Storm Lake Marina
Dock Installation and Site Repairs
Buena Vista County, IA
PROJECT NUMBER: 23-01-11-01

October 18, 2022

Mechanical Electrical Plumbing Lighting Technology IDNR – Ryan Richey Storm Lake Marina

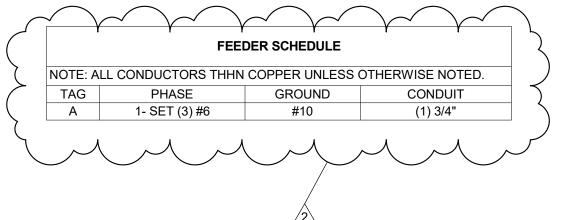
- 1. Drawing E5 ELECTRICAL ONE-LINE DIAGRAM (REFER TO ATTACHED)
 - a. REVISE electrical connections for power pedestal groupings to be connected to 50A-2P GFCI circuit breakers with #6 conductors #10 EGC in ¾" conduit. Connect (4) pedestals per circuit as previously indicated with revised wiring and overcurrent protection devices. Refer to attached revised one-line diagram.
